1 **Annex Q**

5 **DTR Station using the TKP Access Protocol**

7 **Join, Transmit and Monitor Low Level FSMs**

Wilson Paper: 802.5-96/11-05

Figure Q-1 Joint FSM (JS=state): DTR Station using the TKP Access Protocol

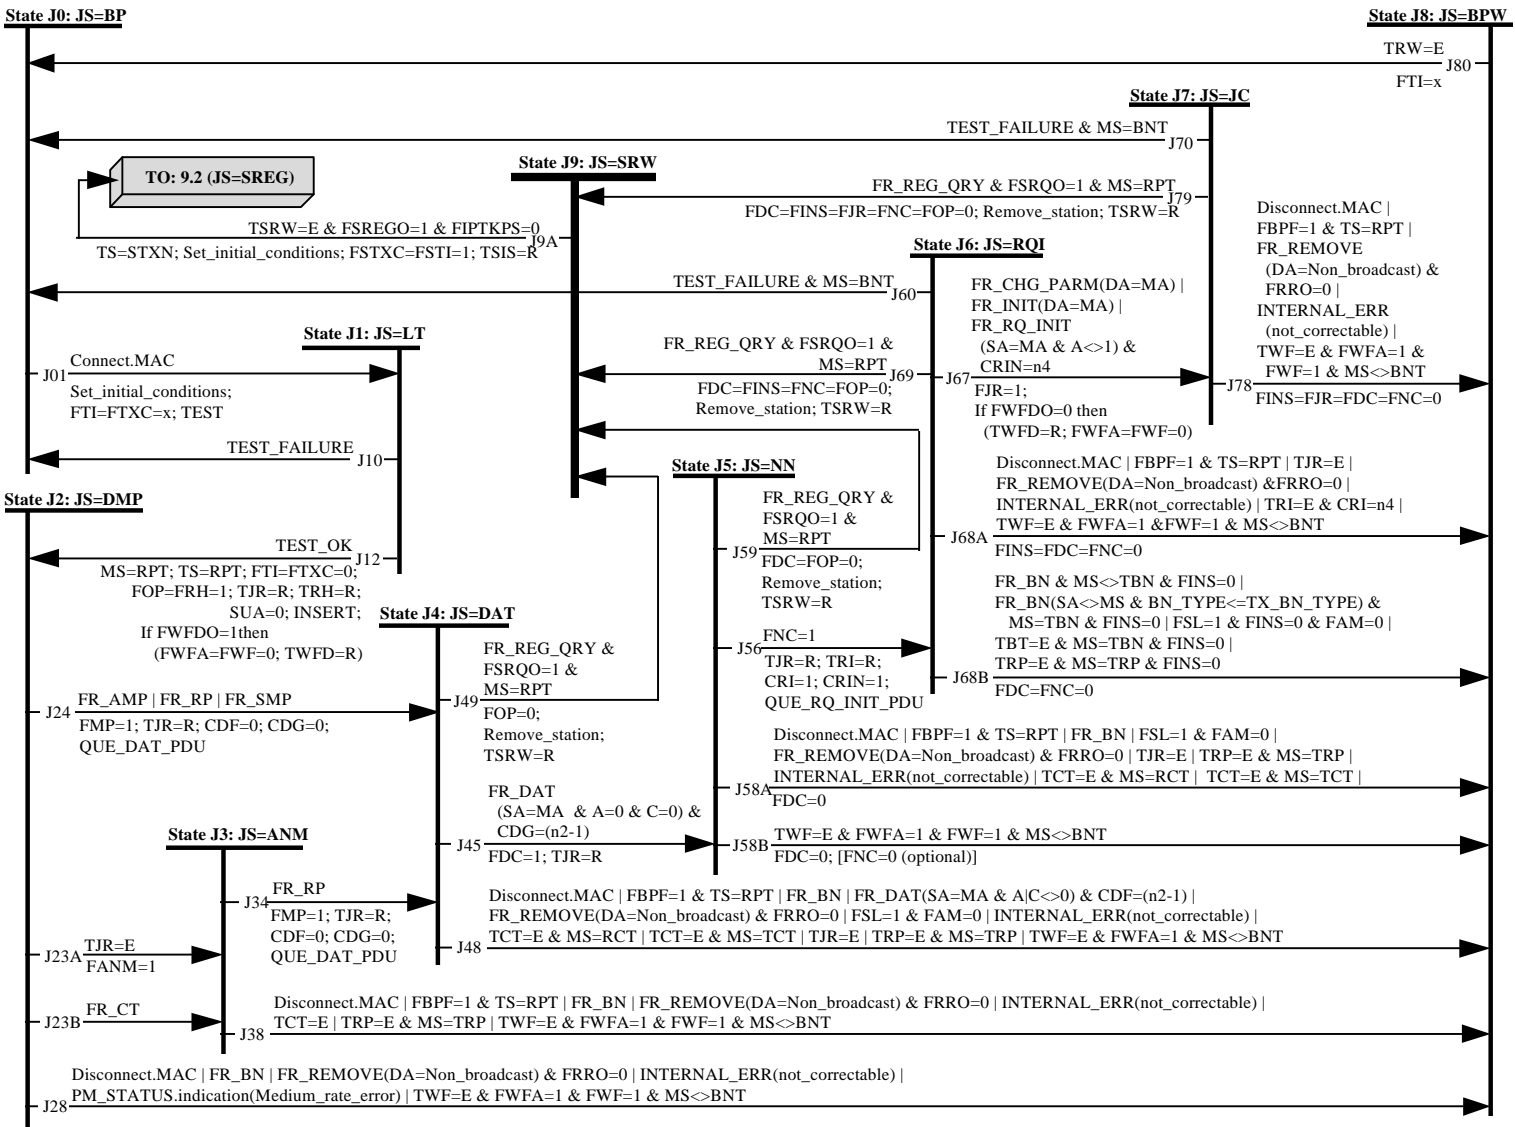
39 A) Figure Q-1 page Q-2 Join FSM has been changed as follows.

40 1) Transition J9A has been corrected as follows.

41 a) The J9A event: The term "TSRW=E & FSREGO=1" is incomplete and has been
42 replaced by: "TSRW=E & FSREGO=1 & FIPTKPS=0".

43 b) The J9A action: The term "TSTXC=FSTI=1" is incorrect and has been replaced by:
44 "FSTXC=FSTI=1".

45 c) The J9A action: The ending semicolon in incorrect and has been removed.

46 2) Transition J12 event: The terms "FTI=0; FTXC=0;" are an incorrect notation and have been
47 replaced by the single term: "FTI=FTXC=0;".

48 3) Transition J24 action: The term "CDF=CDG=0;" is an incorrect notation representation of
49 counters and has been replaced by the two terms: "CDF=0; CDG=0;".

50 4) Transition J34 action: The term "CDF=CDG=0;" is an incorrect notation representation of
51 counters and has been replaced by the two terms: "CDF=0; CDG=0;".

52 5) Transition J38 event: The term "FBPF=1 & MS=RPT" is incorrect and has been replaced
53 by: "FBPF=1 & TS=RPT".

54 6) Transitions J49, J59, J69 and J79 events: The term "FSRW=1" is not in 9.6 and have been
55 replaced by: "FR_REG_QRY & FSRQO= & MS=RPT".

56 7) Transition J48 event: The term "TCT=E & MS=RCT" is missing and has been added.

57 8) Transition J58 has been changed because of a change in 802.5s as follows.

58 a) Transition J58 event: The Transition has been renamed J58A and term "TWF=E &
59 FWFA=1 & FWF=1 & MS<>BNT" has been moved to the new Transition J58B.

60 b) Transition J58 action: The Transition has been renamed J58A and term "FDC=0" has
61 been added to agree with 9.6.

62 9) A new Transition, J58B, has been added as follows.

63 a) The J58B event is as follows.

64 TWF=E & FWFA=1 & FWF=1 & MS<>BNT

65 b) The J58B action is as follows.

66 FDC=0; [FNC=0 (optional)]

67 10) Transition J68B event has been changed as follows.

68 a) The term "FR_BN & MS<>TBN & FINS=1" is incorrect and has been replaced by:
69 "FR_BN & MS<>TBN & FINS=0".

70 b) The term "FSL=1 & FINS=0 & FAM=0" is missing and has been added.

71 11) Transition J68A event: The event has been reformatted to prevent the division of the term:
72 "TRI=E & CRI=n4". The events remain the same.

Figure Q-2 Transmit FSM (TS=state): DTR Station using the TKP Access Protocol

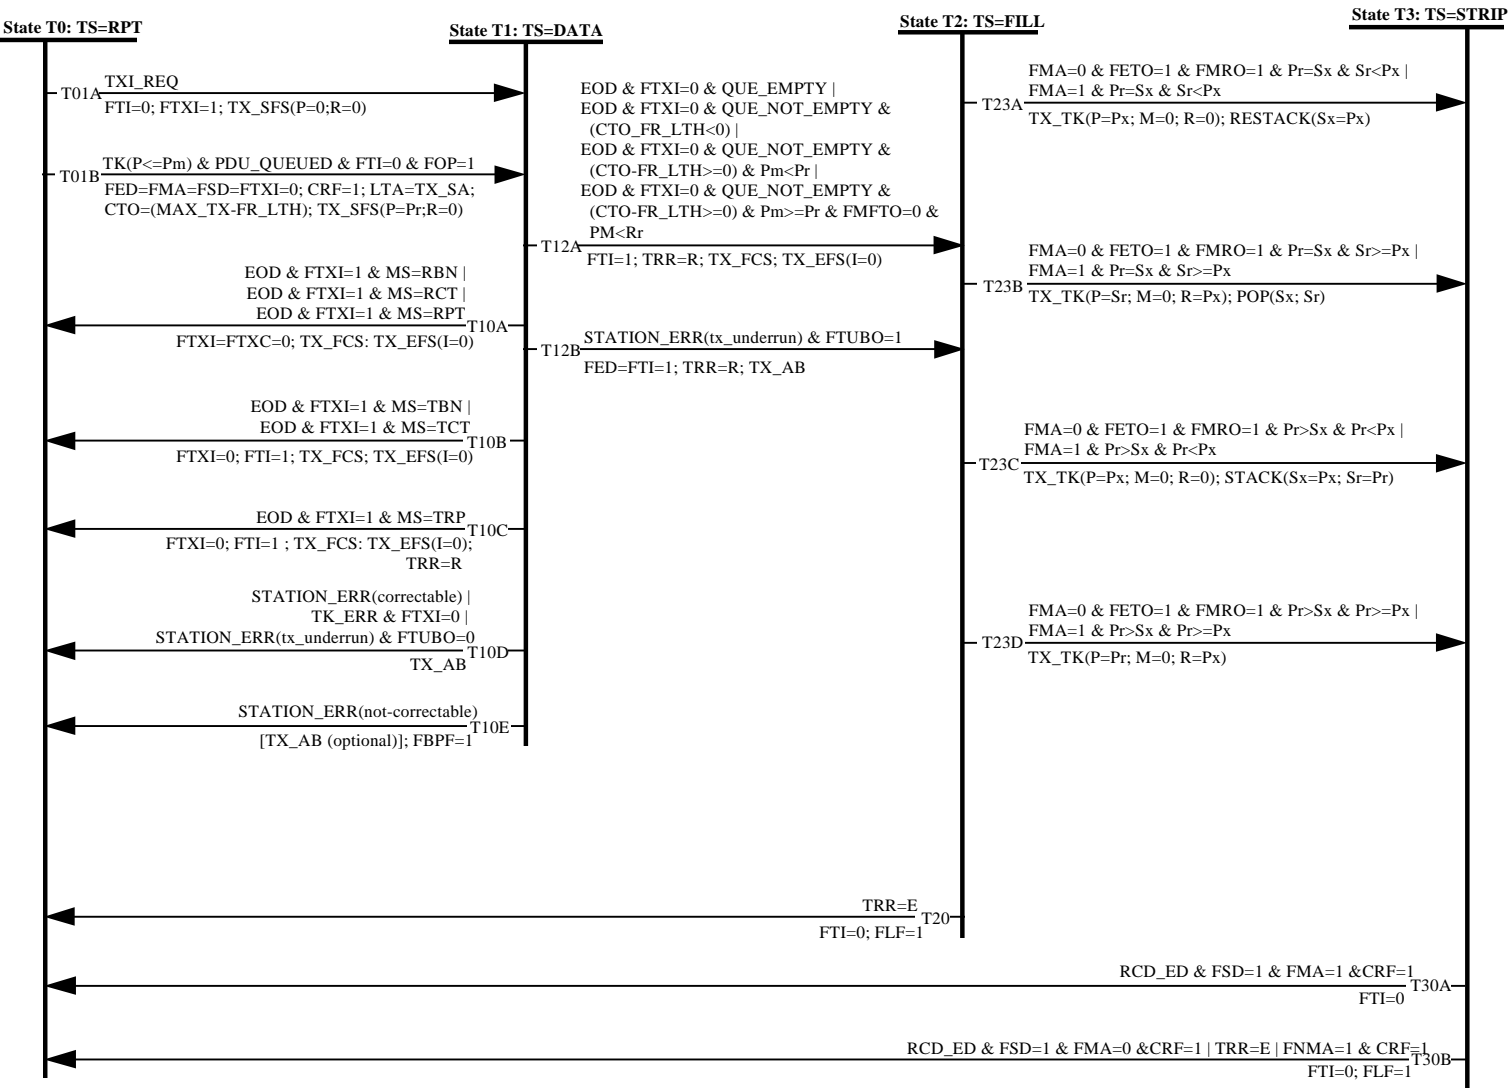
- 73 B) Figure Q-2 page Q-3 Transmit FSM has been changed as follows.
- 74 1) Transition T12A action: The term "TRR=E" is incorrect and has been replaced by "TRR=R".

- 75 2) Transition T12B action: The term "TRR=E" is incorrect and has been replaced by "TRR=R".
- 76 3) Transition T23D event: The term "Pr=Sx & Sr<Px" is incorrect and has been replaced with

Figure Q-3 Monitor FSM (MS=state): DTR Station using the TKP Access Protocol

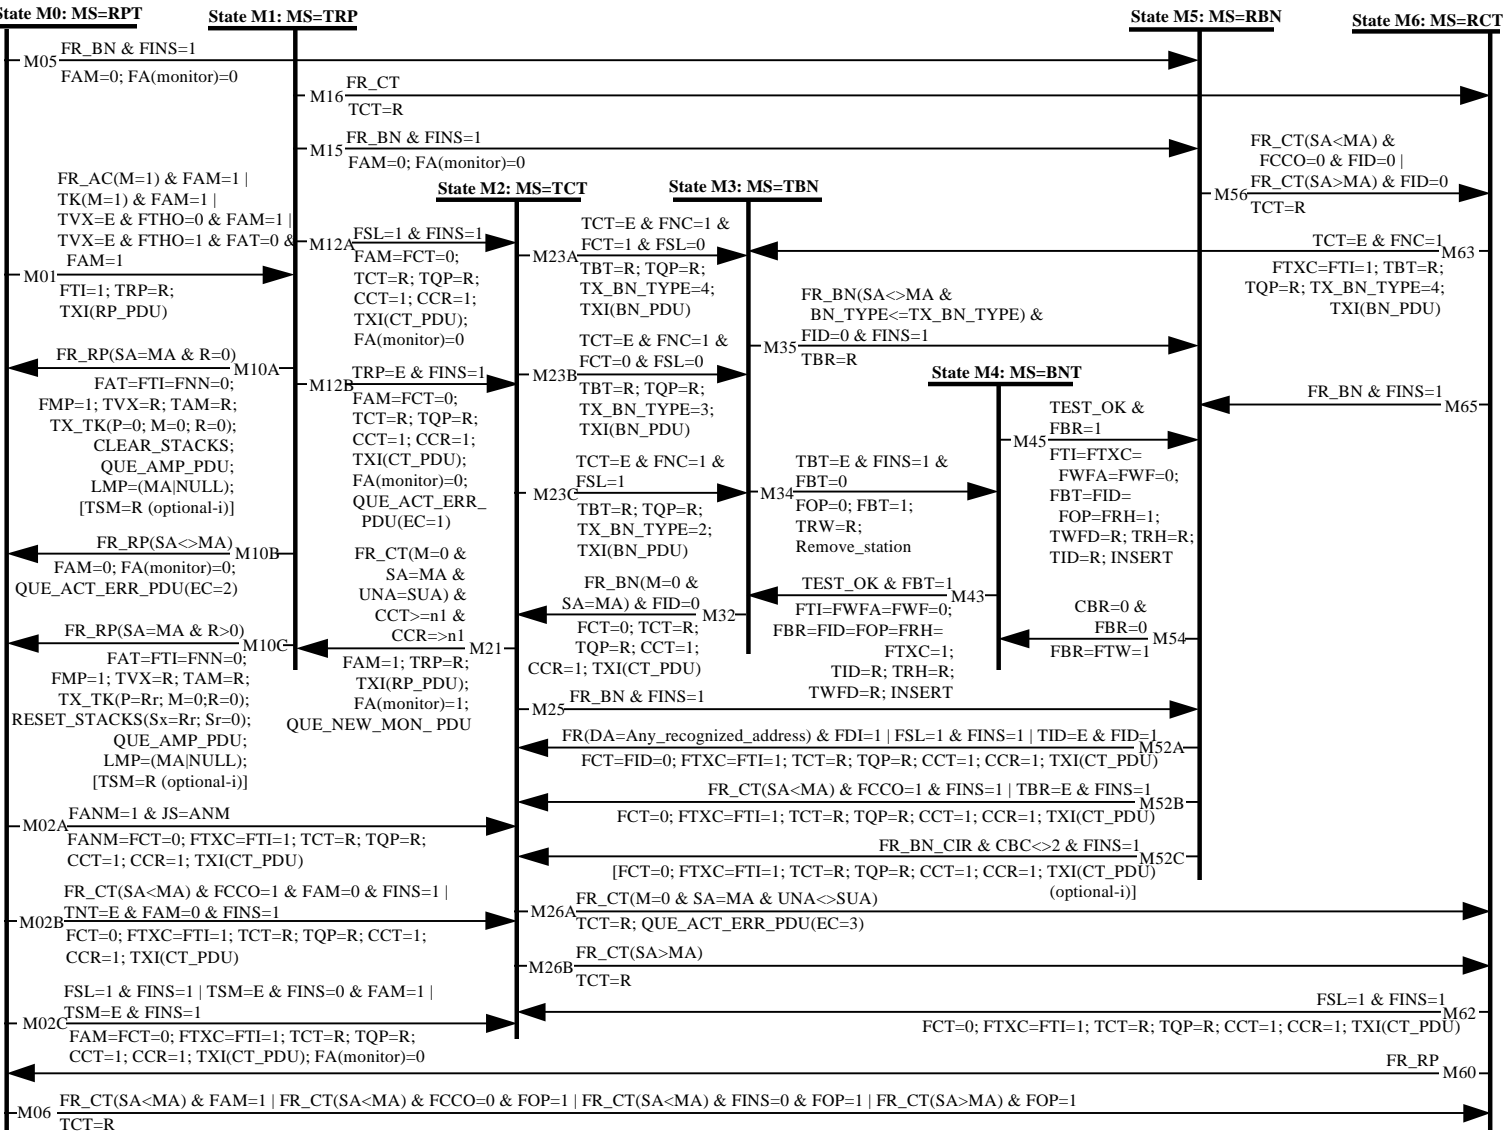
- 77 "Pr>Sx & Pr>=Px"
- 78 C) Figure Q-3 page Q-4 Monitor FSM has been changed as follows.
- 79 1) Transition M02A event: The term "FANM=1 & MS=RPT" is incorrect and has been

- 80 replaced by: "FANM=1 & JS=ANM".
- 81 2) Transition M06 event: The term "FR_CT(SA=MA) & FAM=1" is incorrect and has been
- 82 replaced by "FR_CT(SA<MA) & FAM=1".

- 83 3) Transition M43 action: The term "FBR=FID=FOP=FRH=1" is incorrect and has been
- 84 replaced by: "FBR=FID=FOP=FRH=FTXC=1".
- 85 4) Transition M45 action: The term "TRH=R;" is missing and has been added.

- 86 5) Transition M54 was missing and has been added per 9.6 as follows.
- 87 a) The M54 event is as follows.
- 88 CBR=0 & FDR=0 & FIPTKPS=1
- 89 b) The M54 action is as follows.

- 90 FBR=FTW=1
- 91 6) Transition M65 event: The term "FNC=1" is incorrect and has been replaced by "FINS=1".
